REDRAWN

3 PRONG POLARIZED PLUG WITH REMOVEABLE GROUND CONNECTION.

REQ.	ITEM	PART NO.	DESCRIPTION		SYMBOL				
											THE TECHNICAL MATERIEL CORP. MAMARONECK, NEW YORK						
											POLARIZED AC PLUG						
A	1	REDRAWN NOTE ADDED	11-30-61	5955	RLU												
ISSUE	ITEM	CHANGED FROM	DATE	CH. NO.	DRAFTS	CHECKER	ENG. APP.	MATERIAL									
TOLERANCES			SCALE:					TYPE & TEMPER		HEATTREAT.SPEC.	DRAWN	CHECKED	FINAL APPROVAL				
DEC. DIM. ±			MAXIMUM ALLOWABLE TOLERANCES HAVE BEEN DETERMINED AND ANY DEVIATIONS WILL BE CAUSE FOR REJECTION. REMOVE ALL BURRS AND SHARP EDGES										PL-172				
AC. DIM. ±																A	
ANGULAR DIM. ±																	
								FINISH & SPEC. NO.		ELEC. DES. APP	MECH. DES. APP

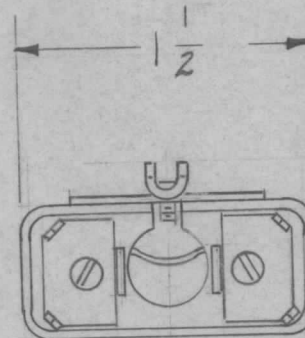
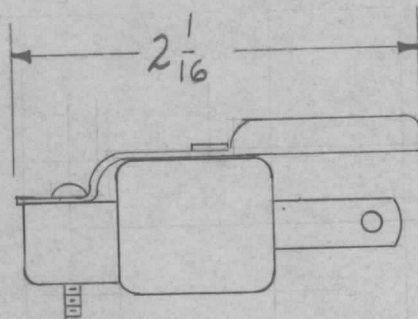
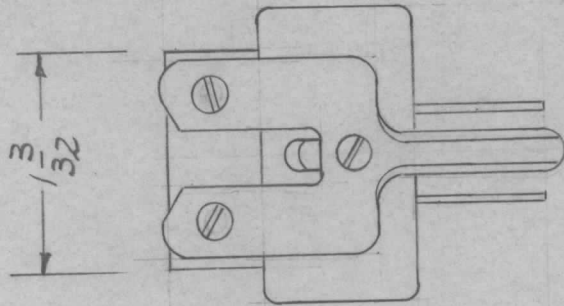
1. TMC part drawing no. PL-172 was in direct conflict w/ Penta Lab part# PL-172.
2. Therefore, to avoid conflict w/ Penta Lab part nos. & TMC part nos. the dwg # PL-172 was changed to PL-218.
